**To:** Robb Klauk, Land Design  
**From:** Pat O’Mahony, Associate Planner; 910-341-3260  
**CC:** File;  
**Date:** 3/28/2024  
**Re:** Dave & Busters TRC Rev. 2

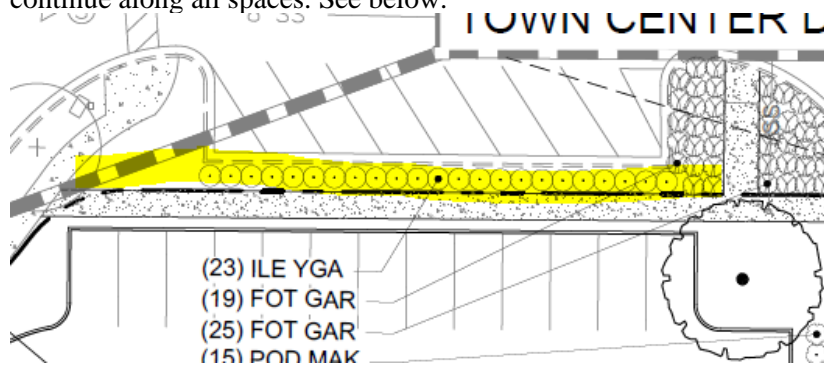
- Submit recombination plat with signatures for recordation.
- CAMA land use classification is “Watershed Resource Protection”.
- Landscape Plan:
  - The parking lot screening shrubs must be 3’ in height at planting and should continue along all spaces. See below.
